Addendum No. 4

PROJECT: ORANGE COUNTY JUSTICE EXPANSION
EAST MARGARET LANE
HILLSBOROUGH, NORTH CAROLINA

PROJECT #: 0417

DATE: 2/2/07

DWG: CBD-1	SCALE: NTS
DATE: 02/02/07	REF DWG: C5.1
BY: WH	CRZ#0417
TITLE: SILT FENCE DETAIL	
PROJECT: ORANGE COUNTY JUSTICE EXPANSION

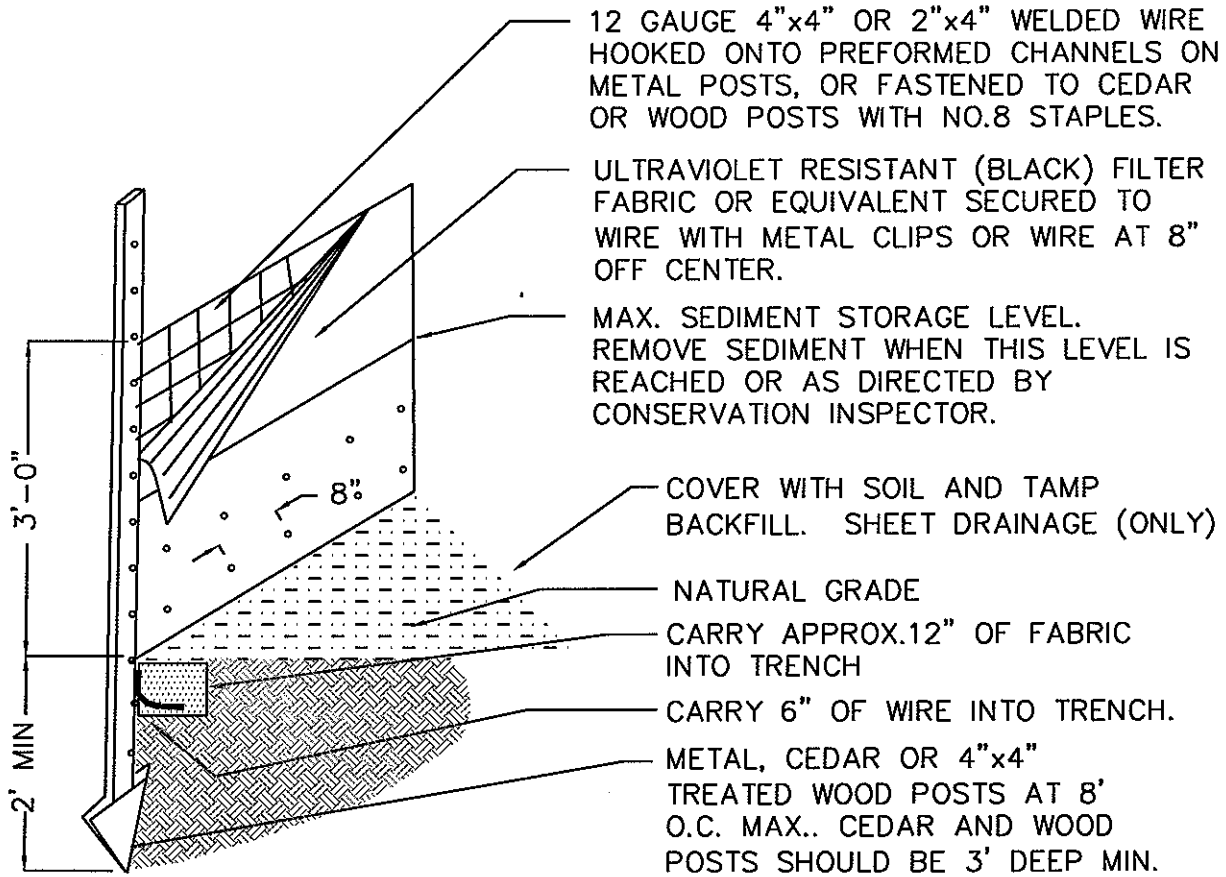
1. **Sheet C5.0:** Add the following note to this sheet: "The Contractor shall protect the park area of the site during the geothermal well drilling operations. This will require that the area be protected by the enclosed silt fence outlet detail prior to any drilling in the area. The layout of the silt fence and outlets need to be reviewed by the engineer prior to the start of the drilling operation. No wells may be drilled without erosion control protection in place." The attached bulletin drawing, CBD-1, is provided as a detail for the silt fence.

Date	2/2/07	Dwg.	ABD-15
Scale	3" = 1'-0"	Ref. Dwg.	10/A7.3
Title	Stair Detail at Stair S-3		
Project	Orange County Justice Expansion Hillsborough, North Carolina

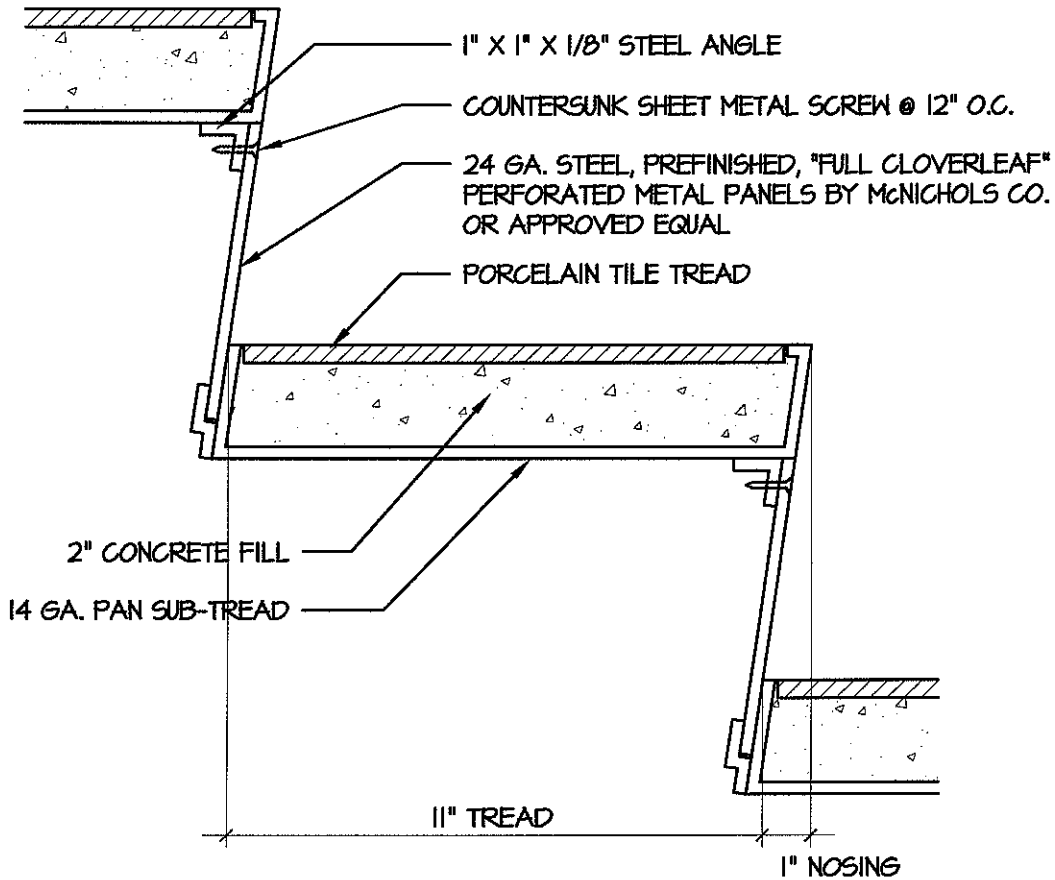
8. **Sheet A7.2:** On 8/A7.2, clarify dimensions of the New Exterior Staircase as shown on the attached bulletin drawing, ABD-20.
9. **Sheet A7.3:** Add details related to the Monumental Stair in Lobby 101 per the attached bulletin drawings, ABD-15 and ABD-16.

Date	2/2/07	Dwg.	ABD-17
Scale	3/4" = 1'-0"	Ref. Dwg.	11/A7.3
Title	Revised Clerk's Work Area Elevations 7, 8/A8.4		
Project	Orange County Justice Expansion Hillsborough, North Carolina

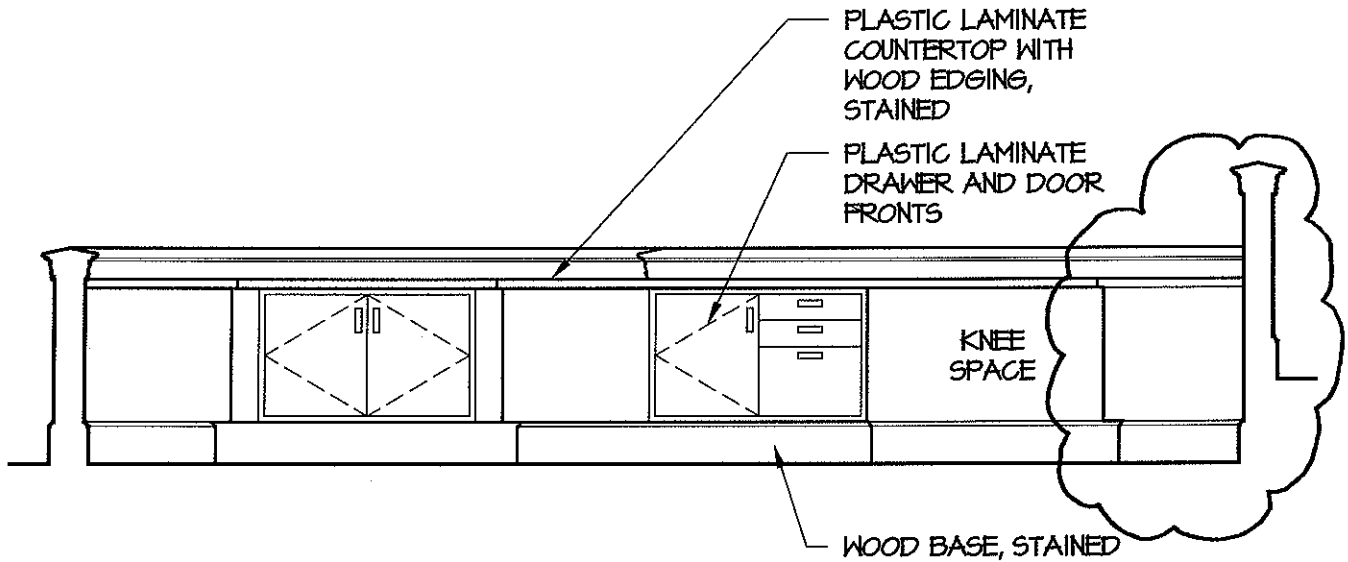
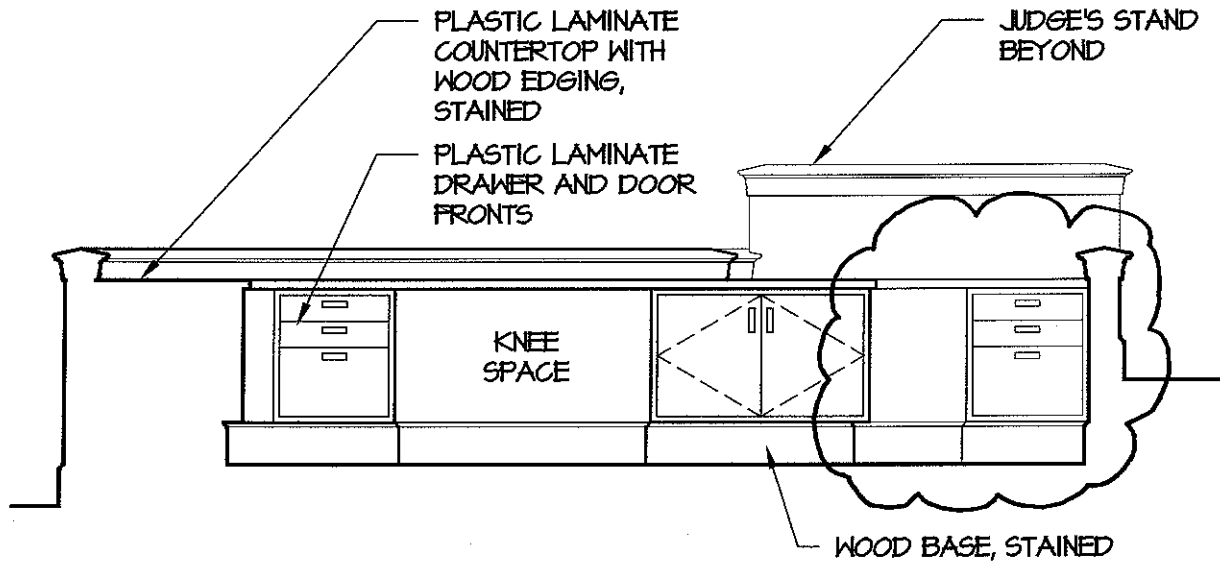
11. **Sheet A8.0 and A8.4:** On 1/A8.0, 7/A8.4 and 8/A8.4, add a return countertop in the Clerk's Station adjacent to the Judge's Stand as shown on the attached bulletin drawing, ABD-17.
12. **Sheet A9.0:** Add one (1) 2" diameter grommet hole and plastic cover at each knee space shown on the casework elevations.
13. **Sheet A9.0:** On 8/A9.0, extend the countertop in elevation 'C' to the adjacent wall as shown on the attached bulletin drawings, ABD-18 and ABD-19.

Date	2/2/07	Dwg.	ABD-21
Scale	1/4" = 1'-0"	Ref. Dwg.	1/A7.2
Title	Partial Section at Elevator A Pit Ladder Added		
Project	Orange County Justice Expansion Hillsborough, North Carolina

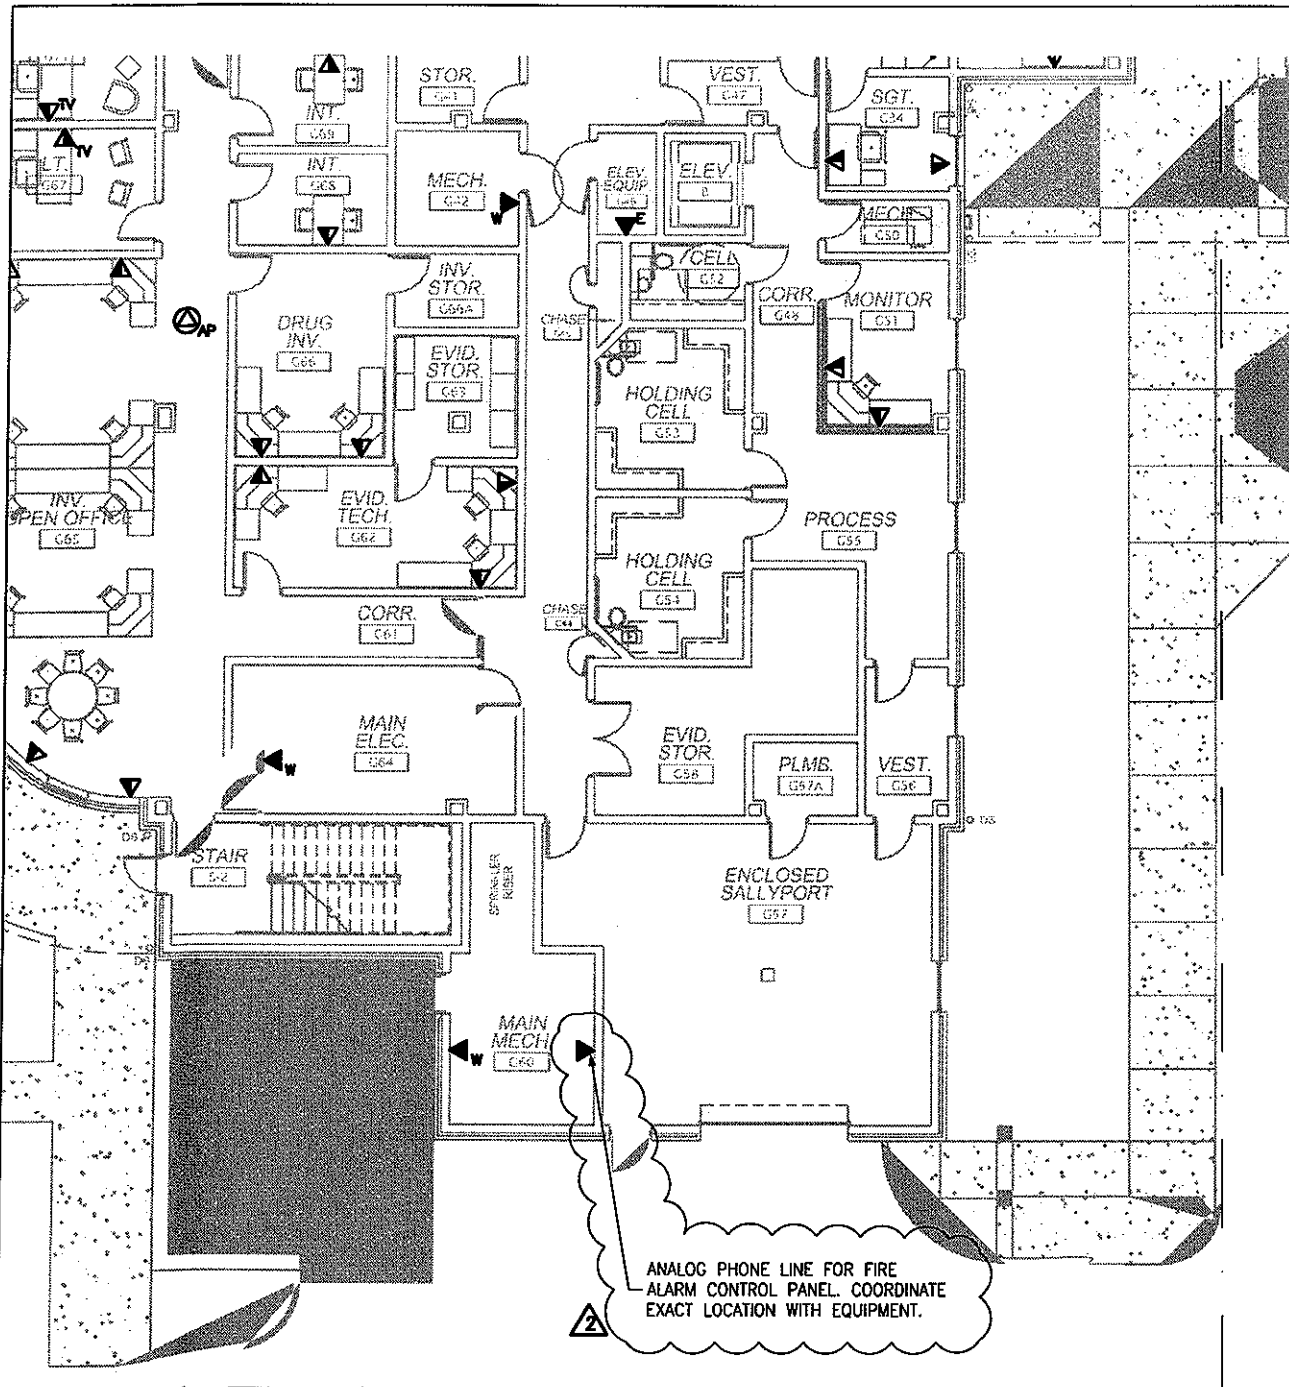
6. **Sheet A2.2:** Add specified Horizontal Blind Window Treatments (H.B.) on interior windows 203A and 217A.
7. **Sheets A7.1 and A7.2:** On 12/A7.1 and 1/A7.2, add a pit ladder in each elevator as per the attached bulletin drawing, ABD-21.
